## 802.4.3.1

### Laundry Tub Connection to Clothes Washer Standpipe

**CHANGE TYPE:** Addition

Laundry tray connected to clothes washer standpipe

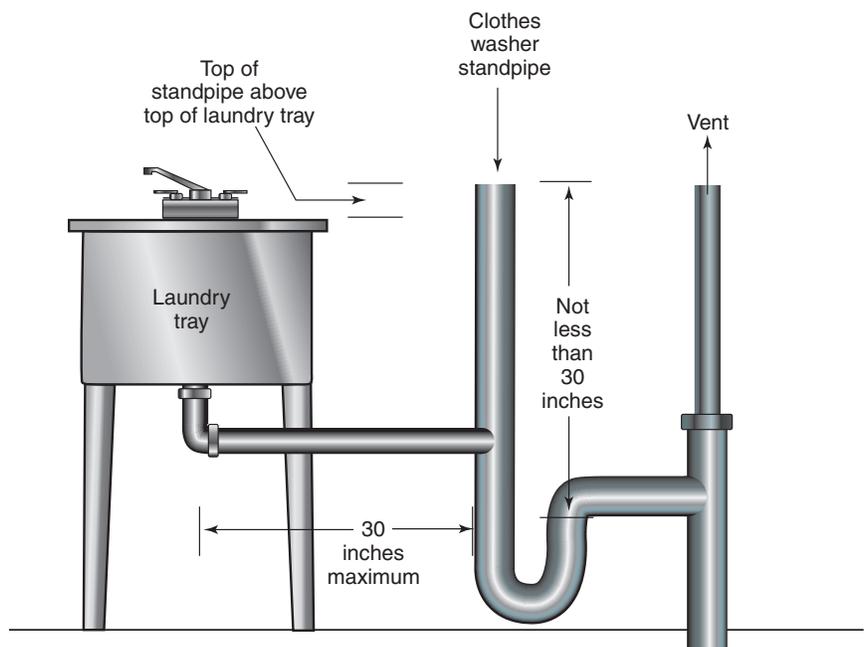
**CHANGE SUMMARY:** An alternative method for connecting a laundry tub drain, without a fixture trap, to a clothes washer standpipe is added to the code.

**CHANGE SIGNIFICANCE:** In the many building arrangements, especially in residential occupancies, a laundry tub is located directly adjacent to a clothes washer. To provide for economy in installing plumbing systems, the code offers an alternative for connecting a laundry tub drain to the clothes washer standpipe. This alternative has been available in the *International Residential Code*® for several editions.

**2018 CODE:** **802.4.3.1 Connection of laundry tray to standpipe.** *As an alternative for a laundry tray fixture connecting directly to a drainage system, a laundry tray waste line without a fixture trap shall connect to a standpipe for an automatic clothes washer drain. The standpipe shall extend not less than 30 inches (732 mm) above the weir of the standpipe trap and shall extend above the flood level rim of the laundry tray. The outlet of the laundry tray shall not be greater than 30 inches (762 mm) horizontal distance from the side of the standpipe.*
